**PLANNED UNIT DEVELOPMENT  
STAFF REPORT****Date: November 6, 2014****DEVELOPMENT NAME**

McConnell Automotive

**LOCATION**3150 Dauphin Street  
(North side of Dauphin Street, 950' ± West of Sage Avenue  
extending to the South side of Dauphin Square Connector).**CITY COUNCIL  
DISTRICT**

**CONTEMPLATED USE**Planned Unit Development Approval to amend a  
previously approved Planned Unit Development to allow multiple buildings on two building sites  
with shared access and parking between the two building sites to include new employee parking.**TIME SCHEDULE  
FOR DEVELOPMENT**

# SITE PLAN

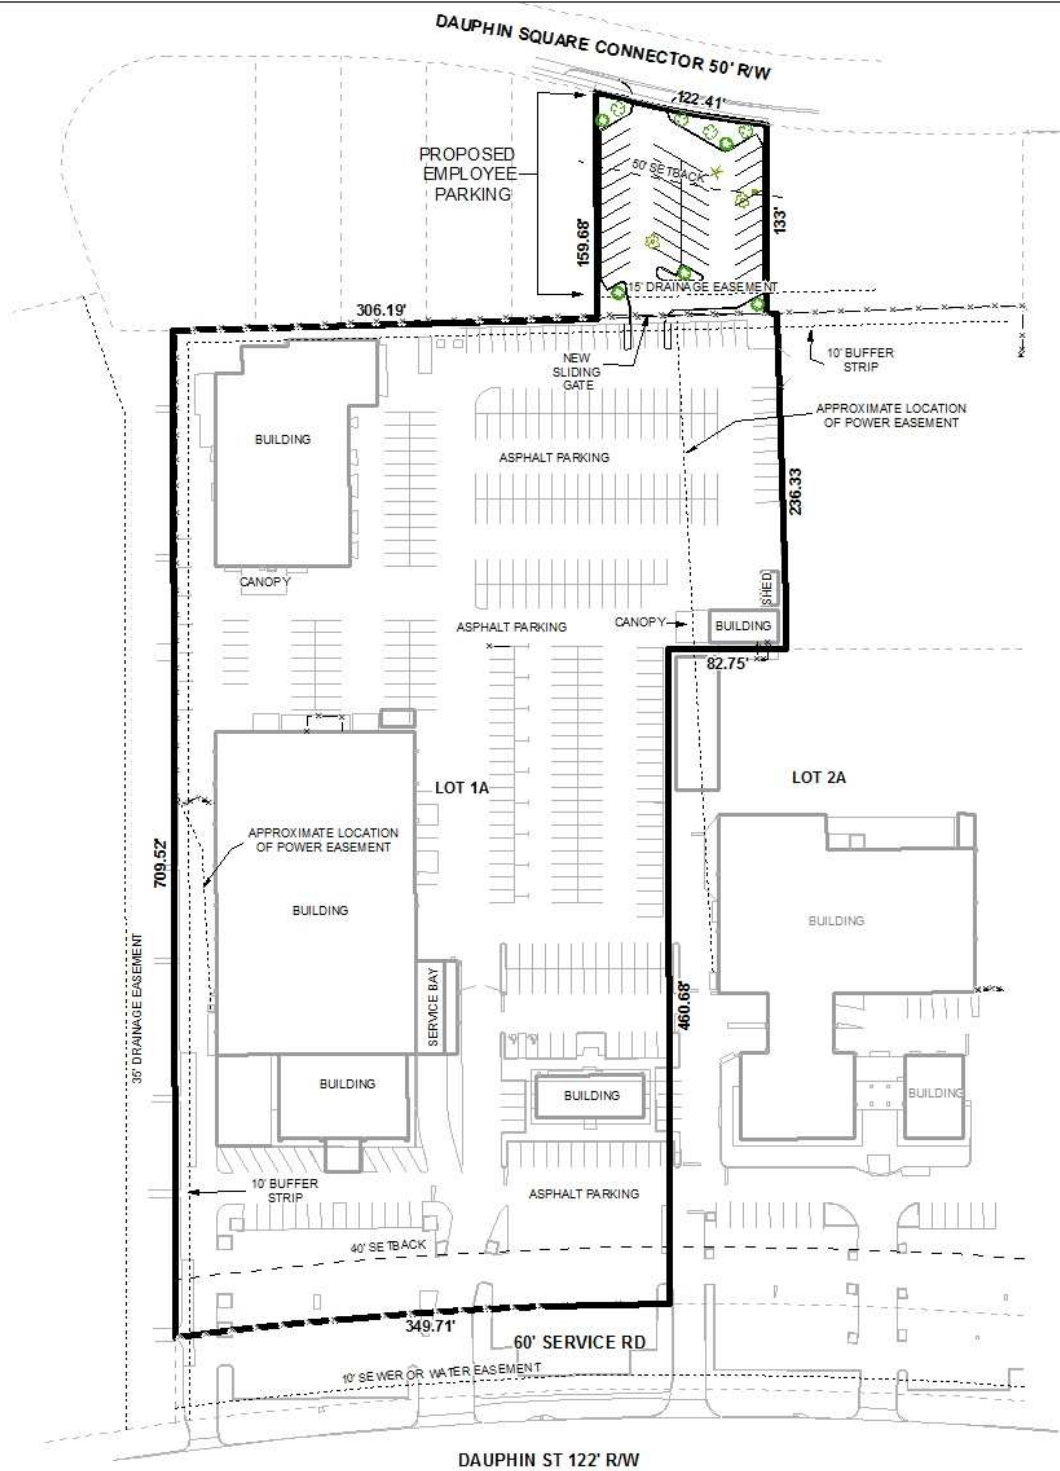
The site fronts onto Dauphin Street, a major street, with a right-of-way illustrated as 122-feet and Dauphin Square Connector, a minor street, with a right-of-way of 50-feet. Both streets meet the minimum right-of-way widths as required by the Subdivision Regulations and the Major Street Component of the Comprehensive Plan. If approved, both the 122' and 50' right-of-way widths and labels should be retained on the site plan.

Access management is a concern, thus the new parking lot site should be limited to one curb-cut to Dauphin Square Connector, while the portion of the site fronting Dauphin Street should be limited to the existing curb-cuts, with the size, design, and location to be approved by Traffic Engineering and conform to AASHTO standards.

proposed parking lot is required to provide 3 frontage trees, 9 perimeter trees, and 2 parking trees. The tree calculations that are proposed on the site plan indicate that applicant will be providing 4 frontage trees and 8 perimeter trees: parking trees are not noted on the plan. The site plan should be revised to depict a total of 14 trees on the site plan, of which 3 must be overstory frontage trees. It should be noted however that no trees will be allowed to be planted within any drainage or utility easements, thus a redesign of the site to provide compliant tree planting areas may be required. Based on the landscaping calculations provided, the site does appear to meet the minimum landscape area requirements.

New lighting on the portion of the site being developed will have to comply with the requirements of Sections 64-4.A.2., 64-6.A.3.c., and 64-6.A.8. of the Zoning Ordinance. The Zoning Ordinance requires all vehicle parking lots containing 25 or more vehicle spaces to provide uniform parking lot lighting; thus, a note reflecting this requirement should appear on the site plan, and photometric plans will be required at the time of submittal for a building permit.

The Zoning Ordinance requires that areas used for the parking and storage of vehicles be paved in asphalt, concrete or similar approved surface. The Ordinance also requires 24-foot wide driveways for two-way access. This information is depicted on the site plan however; any additional area needed in the future for parking or storage of vehicles will require additional paving as well as a revised PUD application.

Lot 1 of Dauphin Square Commercial Park has a storm drain located within a 15-foot wide easement that runs along the property between both Lots 1 and 1A. A note should be placed on the site plan stating no structures shall be constructed or placed in any easements. Trees being planted for credit also should not be planted within the easement.

The site plan depicts a 50' minimum building setback line along Dauphin Square Connector, which should be retained on the site plan and on any revised site plans.

A sidewalk is depicted on the site plan along Dauphin Square Connector and should be constructed as proposed.

The site plan depicts existing trees in the proposed parking spaces. The site plan should be revised to note that the existing trees will be removed from the parking area.

- 1) revision of site plan to comply with full tree and landscaping requirements to include frontage trees, perimeter trees, and parking trees;
- 2) placement of a note on the site plan stating that the site is limited to one curb-cut to Dauphin Square Connector and to the existing curb-cuts onto Dauphin Street, with the size, design and location to be approved by Traffic Engineering and to comply with AASHTO standards;

- 3) retention of the 50' minimum building setback line along Dauphin Square Connector;
- 4) revision of the site plan to note that existing trees within the parking area will be removed;

- 5) placement of a note on the site plan stating that no structures shall be constructed or placed in any easements;
- 6) placement of a note on the site plan stating that compliance with Section 64-4.A.2., 646.A.3.c., and 64-6.A.8. of the Zoning Ordinance pertaining to the lighting requirements of parking lots is required;

- 7) retention of the sidewalk along Dauphin Square Connector;
- 8) provision of 2 revised site plans prior to the submission for building permits;
- 9) compliance with Engineering comments: *"ADD THE FOLLOWING NOTES TO THE PUD SITE PLAN: 1. Any work performed in the existing ROW (right-of-way) such as driveways, sidewalks, utility connections, grading, drainage, irrigation, or landscaping will require a ROW permit from the City of Mobile Engineering Department (208-6070) and must comply with the City of Mobile Right-of-Way Construction and Administration Ordinance (Mobile City Code, Chapter 57, Article VIII). 2. A Land Disturbance Permit application shall be submitted for any proposed land disturbing activity with the property. A complete set of construction plans including, but not limited to, drainage, utilities, grading, storm water detention systems, paving, and all above ground structures, will need to be included with the Land Disturbance permit. This Permit must be submitted, approved, and issued prior to beginning any of the construction work. 3. Any and all proposed land disturbing activity within the property will need to be submitted for review and be in conformance with Mobile City Code, Chapter 17, Storm Water Management and Flood Control); the City of Mobile, Alabama Flood Plain Management Plan (1984); and, the Rules For Erosion and Sedimentation Control and Storm Water Runoff Control. 4. The proposed development must comply with all Engineering Department Policy Letters."*;
